CASE: UM 1910/1911/1912
WITNESS: BRITTANY ANDRUS

**PUBLIC UTILITY COMMISSION
OF
OREGON**

STAFF EXHIBIT 100

March 16, 2018

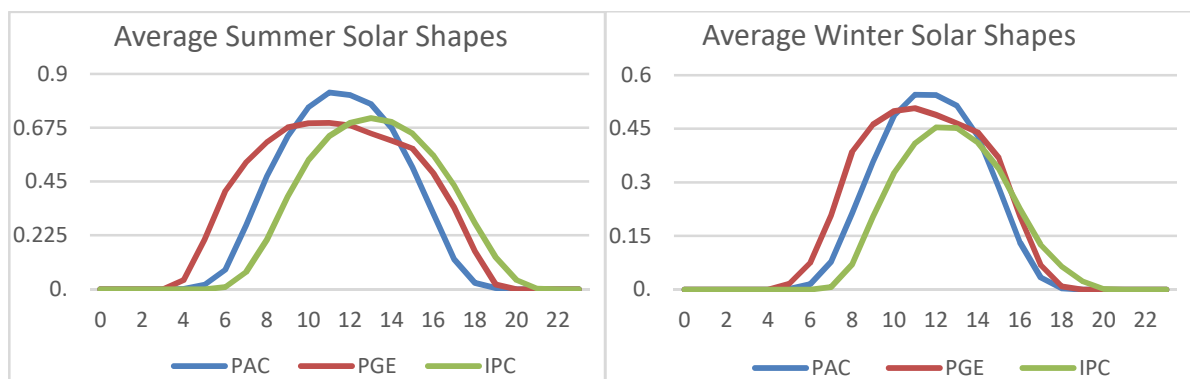
3 A. Staff provides quarterly comparisons of each utility's results in the four
 4 graphs below.

5
 6 **Q. Does Staff have any observations regarding the forward market price**
 7 **curves used by the utilities?**

8 A. It is not clear from Order No. 17-357 whether the Commission intended for
 9 the utilities to use the exact same market prices for RVOS that are
 10 incorporated into the utilities' current standard avoided cost prices or merely
 11 to use the same source for forward price curves,

12 Staff believes that the utilities should use the same source of forward
 13 price curves that is used for their standard avoided cost prices, but does not

4 Staff recommends that the Commission clarify that the Phase I
5 Methodology only requires the same source of forward market prices as is
6 use for standard avoided cost prices and that the Commission expects
7 utilities to use the most recent forward market price curve that is available at
8 the time the RVOS filing is prepared.
